Architect's Supplemental Instructions

Architect's ASI No: 070

Project:
Webster University
Interdisciplinary Science
Building

Reconfiguration of Rain Garden 2 due to discovery of underground fuel oil tank.

SITE
GRADING
PLAN

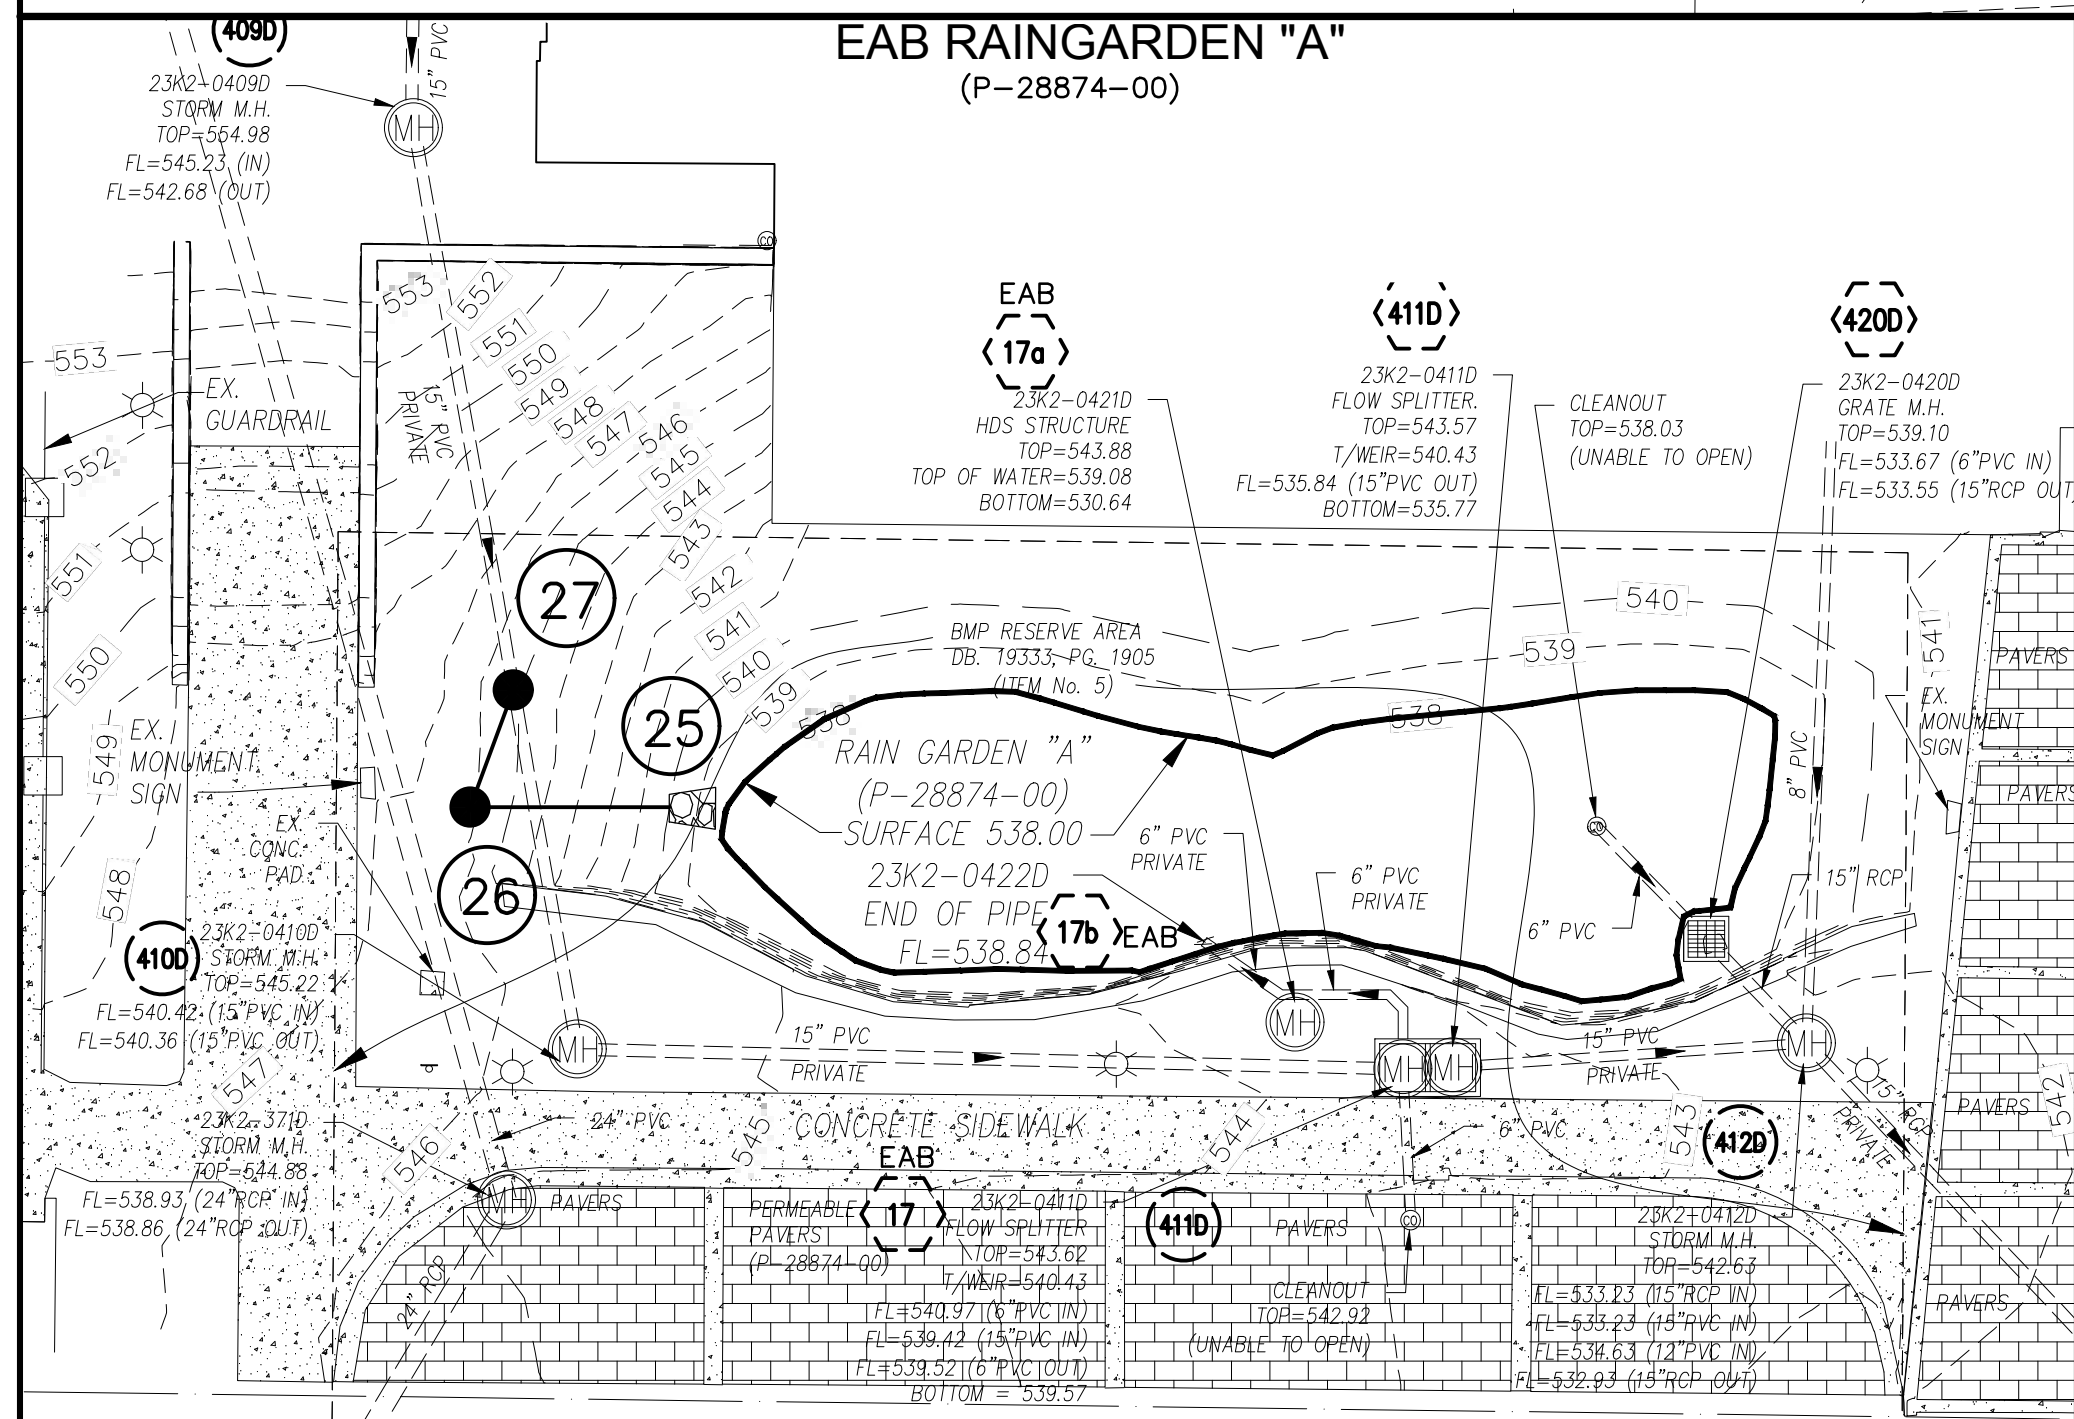
3	ASI 070 RAIN GARDEN 2 RECONFIG	09 JUN 2017
2	ASI 054	08 MAR 2017
1	ADDENDUM 1-1	29 JAN 2016
-	ISSUED FOR CONSTRUCTION (BPT)	15 JAN 2016
No.	Description	Date

BASIN
SECTIONS

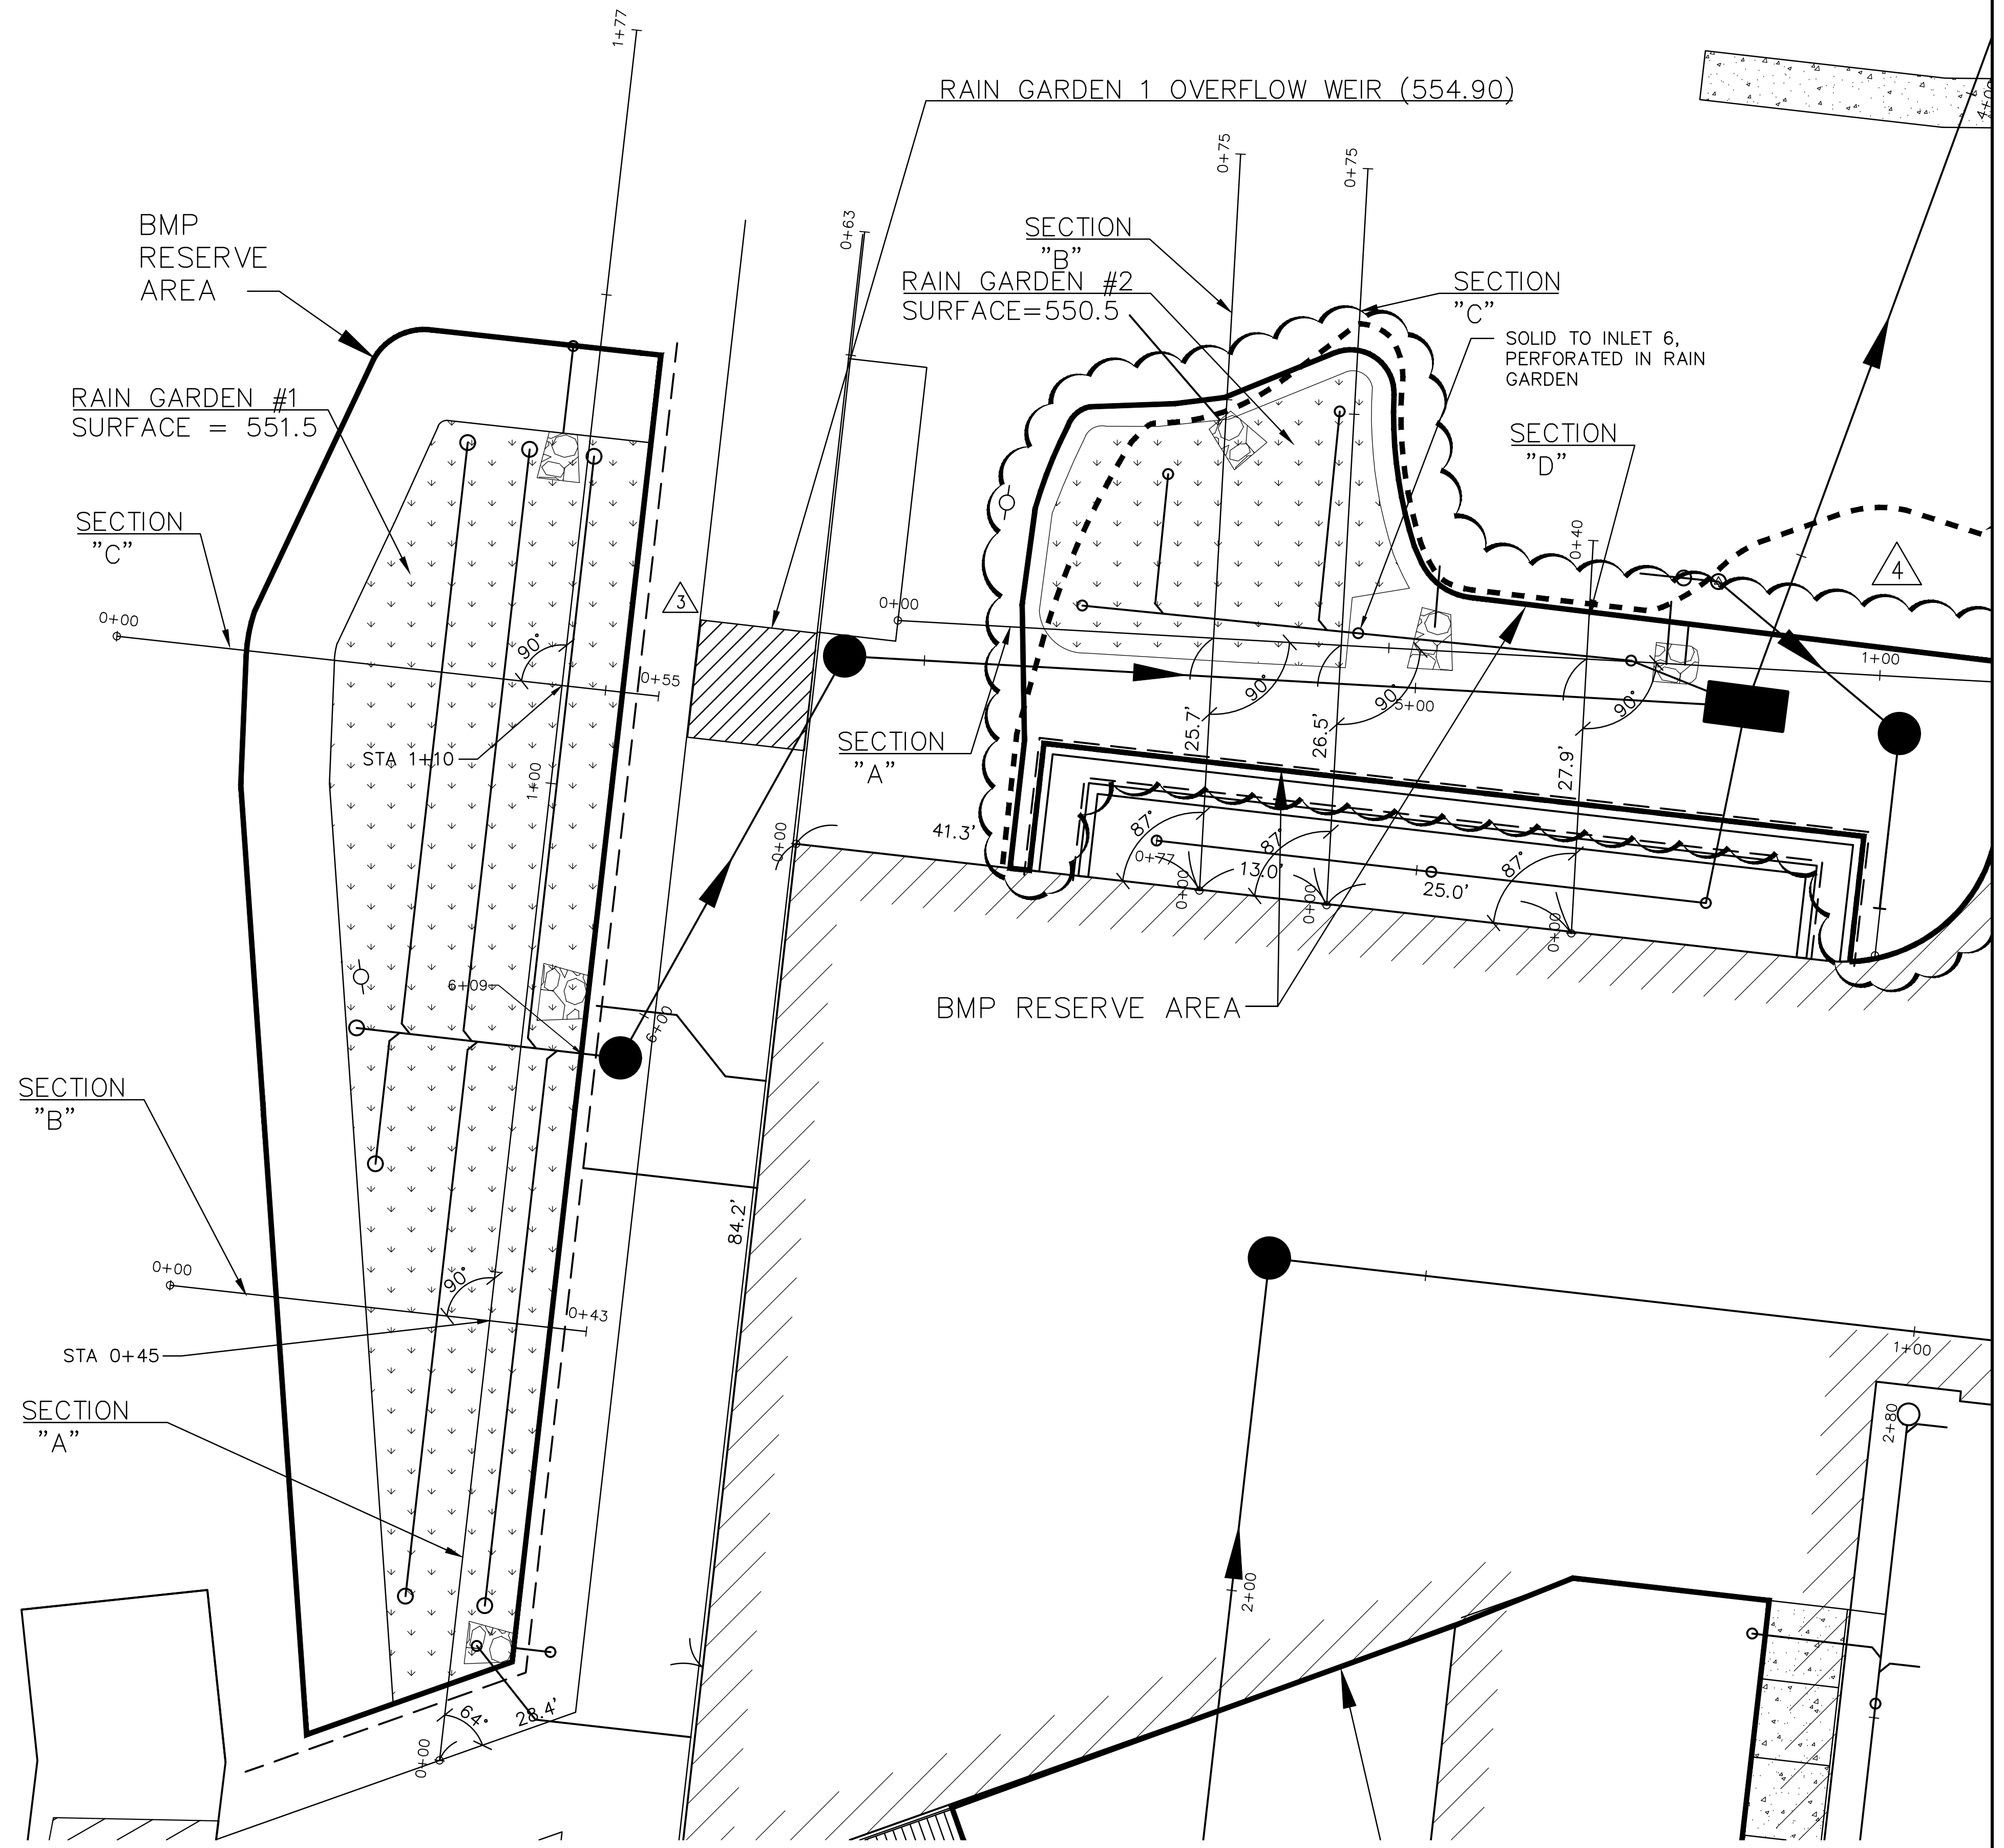
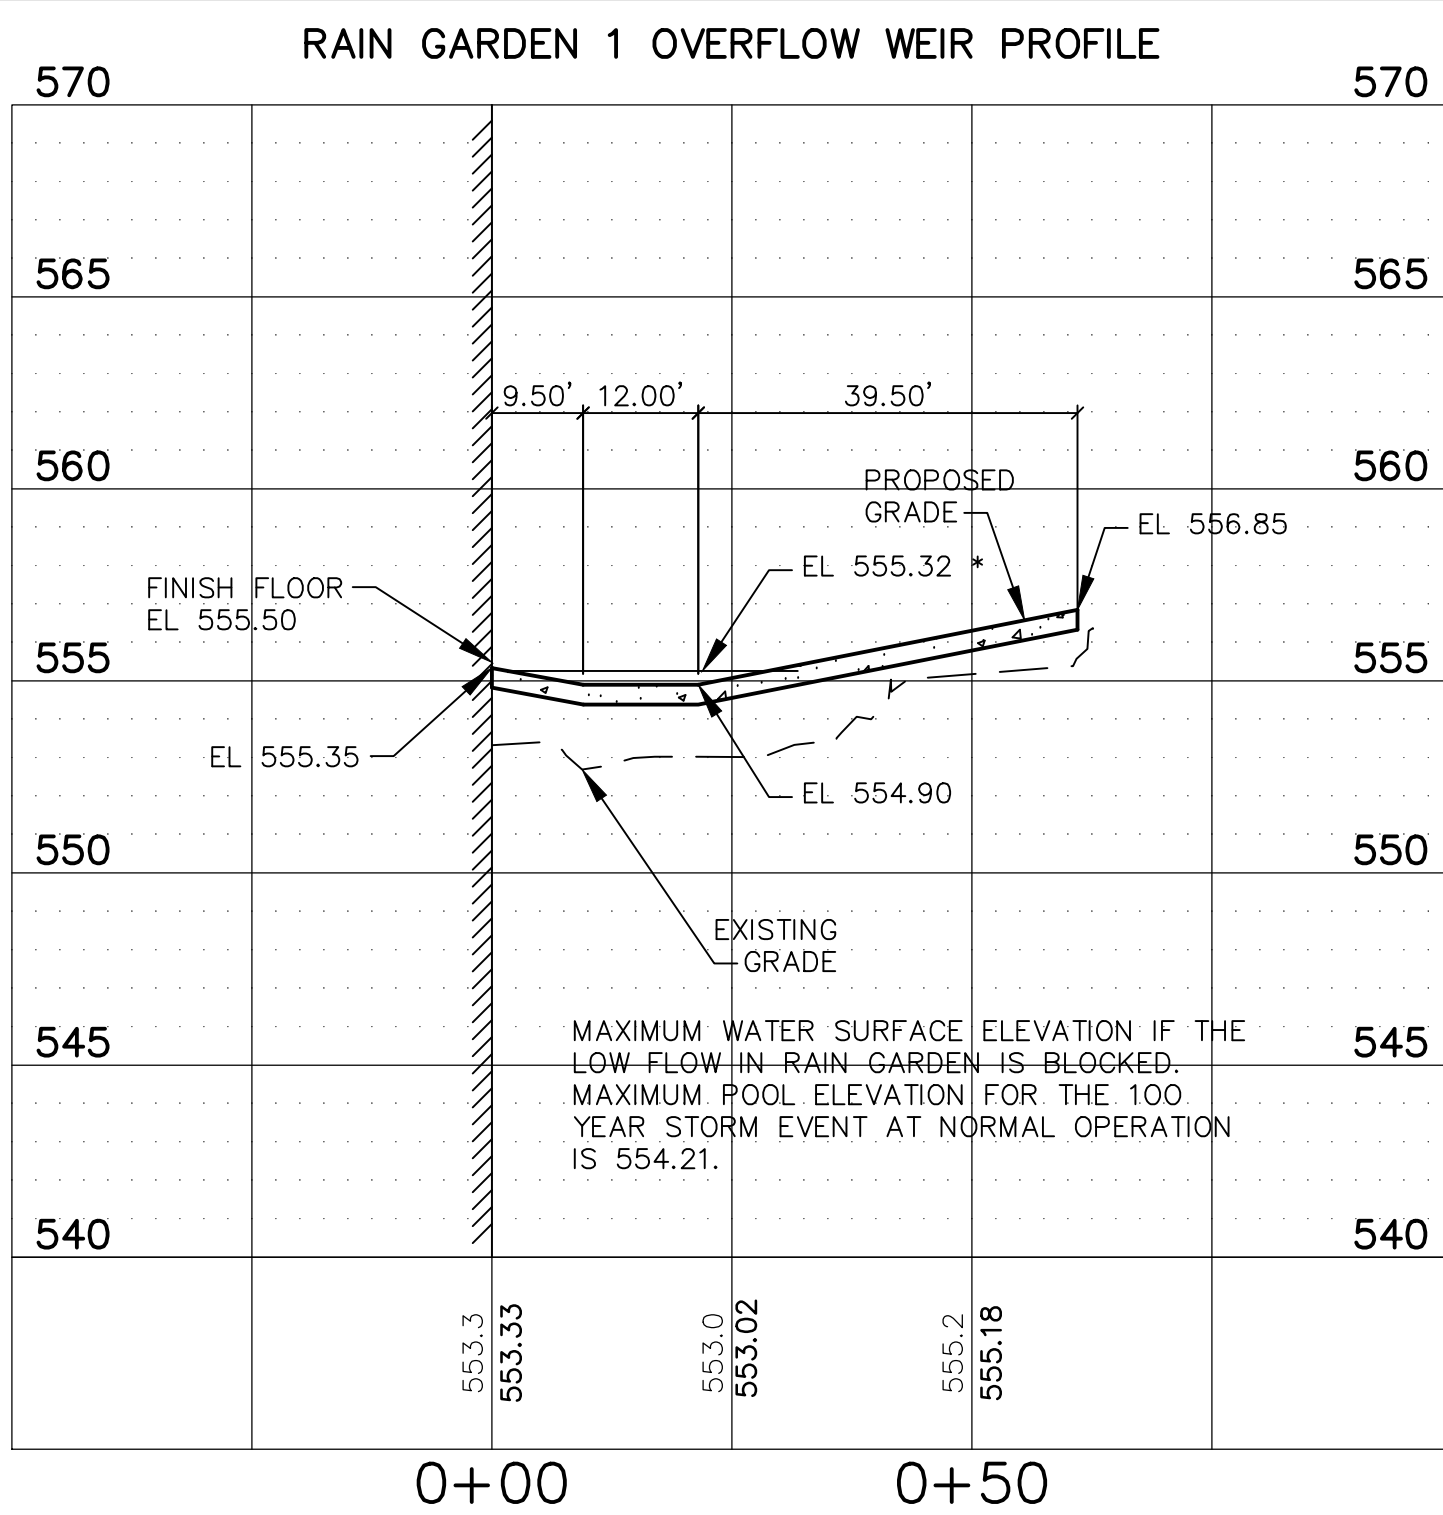
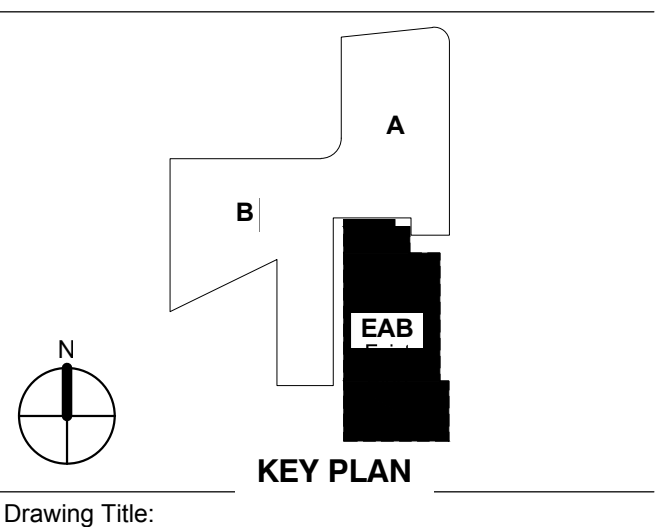
4	ASI 070 RAIN GARDEN 2 RECONFIG	09 JUN 2017
3	ADDENDUM 1-12	16 JUN 2016
2	ADDENDUM 1-10	5 MAY 2016
1	ADDENDUM 1-1	29 JAN 2016
-	ISSUED FOR CONSTRUCTION (BP1)	15 JAN 2016
